FIRE SAFETY INSPECTION REPORT

**MODISTE (CEPZ) LTD,
PLOT NO # 33-36, SECTOR # 07, EXPORT
PROCESSING ZONE**

ACCORD
on Fire and Building Safety in Bangladesh

June 2, 2014

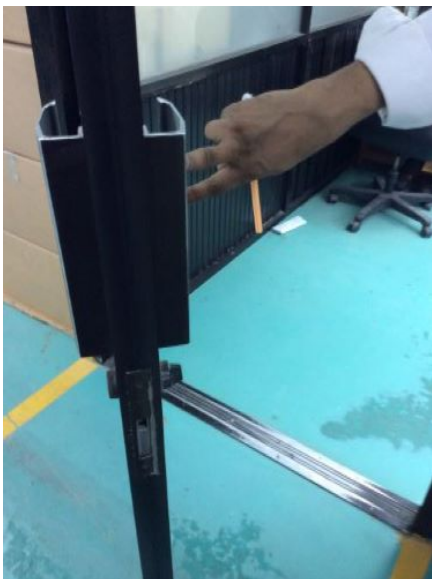
F-2	Fire Rated Construction	Areas used for combustible storage are not separated by fire-rated construction on all floors.	Provide dedicated storage rooms separated by minimum 1-hr fire-rated construction.	Within 3 months

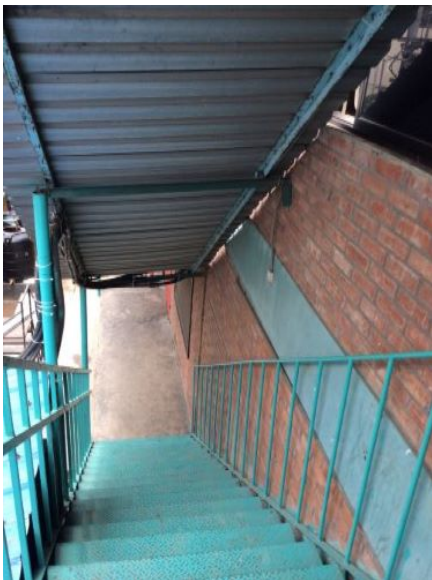
F-7	Egress	Unsealed penetrations and openings are located in exit stair enclosures.	Seal all penetrations and openings in exit stair enclosure walls to maintain the fire separation.	Within 3 months
-----	--------	--	---	-----------------

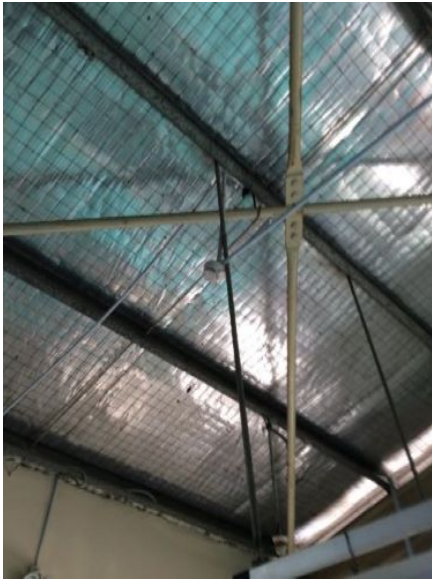
F-9	Fire Protection	The conduits, conduit supports, and smoke detector supports installed are not the correct type.	Provide RSC conduits or Raceway type system for wires and Hanger support system	Within 3 months
-----	-----------------	---	---	-----------------
